**SUBJECT:** **NEW VEHICLE DEMONSTRATION / DELIVERY HOLD Safety Recall 21S31**  
Certain 2020 - 2021 Model Year F-350 Pickup Trucks Equipped with 6.7L Diesel Engine and Single Rear Wheel Axle – **Supplement #4**  
Spring Seat Weld

**New! REASON FOR THIS SUPPLEMENT**

- *Attachments II: Labor Allowances – Additional Labor Op for U-bolt modification added.*
- *Parts Requirements – Ordering Information: additional information for U-bolt usage.*
- *Attachment III: Technical Information-U-Bolt modification as needed.*

FIGURE 12

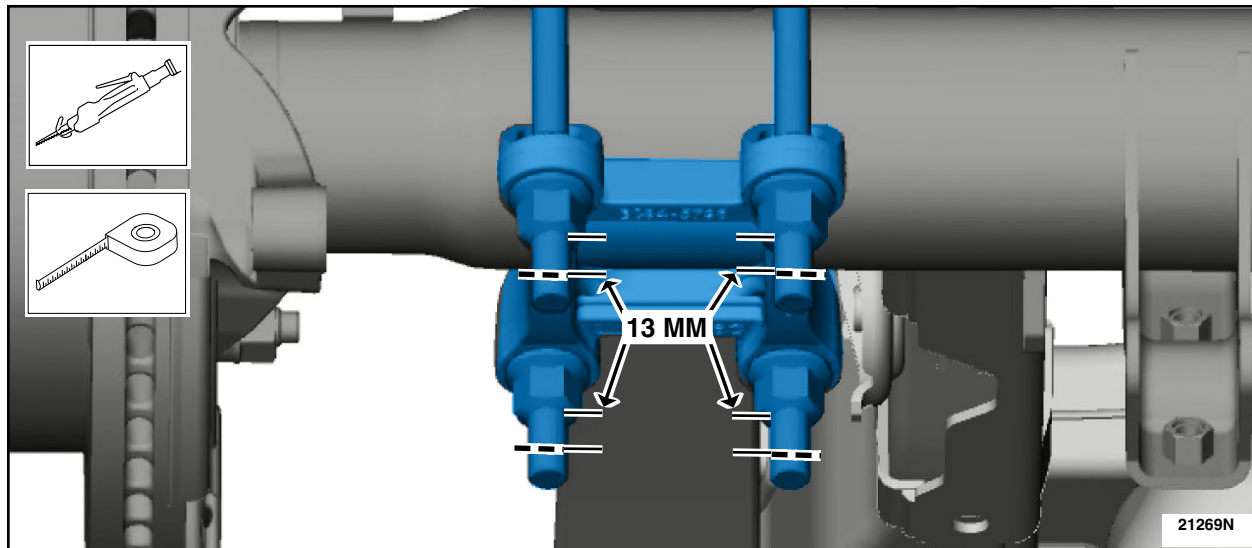
**NOTE:** The following step only applies if U-Bolt # HC3Z-5705-E is used on non-Tremor vehicles.

21. After torquing the U-bolts, measure 13 mm (0.51 in) from the top of the U-bolt nut towards the end of the U-bolt and cut the U-bolt. Make sure to remove any burrs, debris or sharp edges from the U-bolt after cutting. See Figure 12.
